# SERVICE BULLETIN

SERVICE BULLETIN NO: 28-011

## FUEL - DISTRIBUTION FUEL BOOSTER PUMP - DAMAGE TO WIRES DURING INSTALLATION

Lead Protection - Installation  
Figure 1

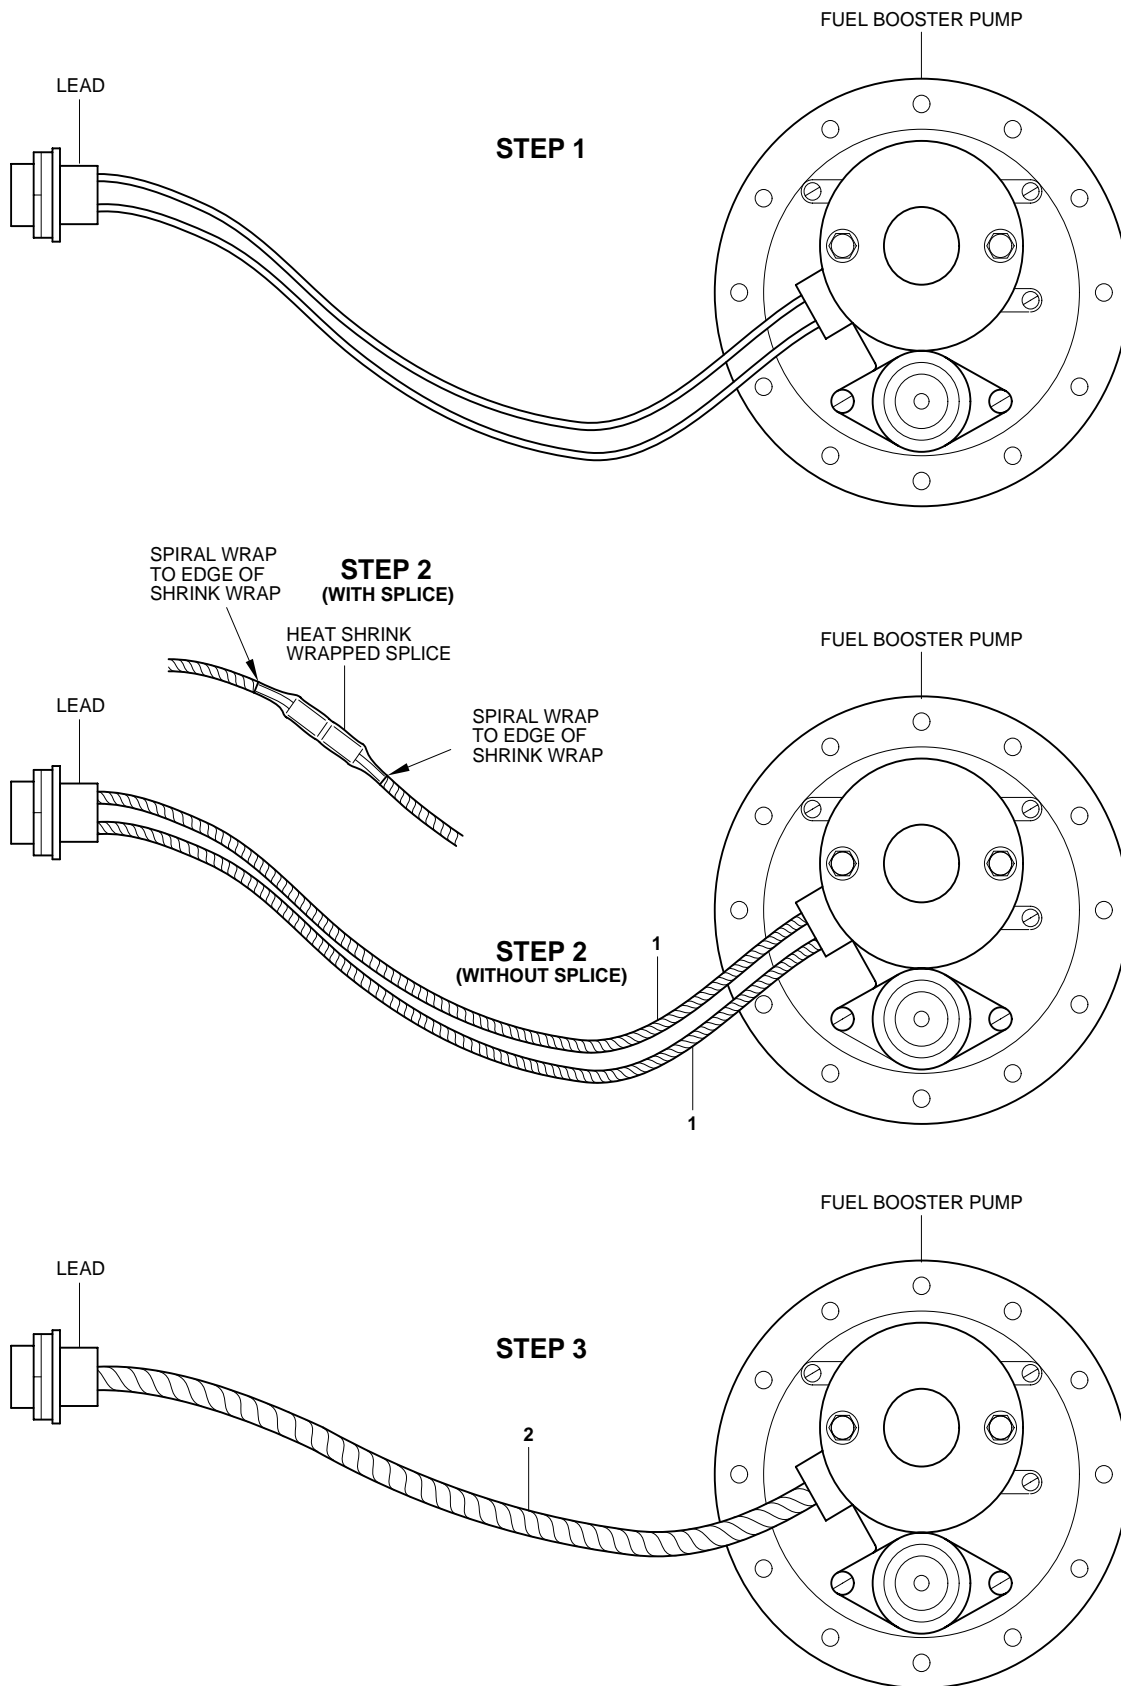
It is possible the electrical power wires (leads) to the left and right fuel pumps are damaged. This could possibly cause electric arcs from the leads in an air/fuel mixture which could result in an unsafe condition.

Damage can occur to the leads during the installation of the pump. It is also possible that during aircraft operation the leads can rub.

**C. Installation of the Lead Protection (Ref. Fig. 1)**

- (2) Install the spiral wrap on each wire:
  - (a) For a wire with no splice. Wind spiral wrap (1) around the full length of the wire. Twist the spiral wrap (1) to make sure there are no gaps and cut the spiral wrap (1).
  - (b) For a wire with a splice. Wind spiral wrap (1) around the wire between the edge of the shrink wrap and the end of the wire. Twist the spiral wrap (1) to make sure there are no gaps and cut the spiral wrap (1). Do this for each side of the splice.

- (3) Release the black wire and the white wire.
- (4) Wind the spiral wrap (2) around the full length of the black wire and the white wire. Twist the spiral wrap (2) to make sure there are no gaps and cut the spiral wrap (2).
- (5) Reidentify the Fuel Booster Pump, Part No. 968.84.11.403 or 968.84.11.404 when this Service Bulletin is done. Use a stamp or vibropen to put the letter B immediately after the Serial Number on the fuel pump Identification plate.

- (3) Install the spiral wrap on each wire:
  - (a) For a wire with no splice. Wind spiral wrap (1) around the full length of the wire. Twist the spiral wrap (1) to make sure there are no gaps and cut the spiral wrap (1).

- (b) For a wire with a splice. Wind spiral wrap (1) around the wire between the edge of the shrink wrap and the end of the wire. Twist the spiral wrap (1) to make sure there are no gaps and cut the spiral wrap (1). Do this for each side of the splice.

- (4) Release the black wire and the white wire.
- (5) Wind the spiral wrap (2) around the full length of the black wire and the white wire. Twist the spiral wrap (2) to make sure there are no gaps and cut the spiral wrap (2).
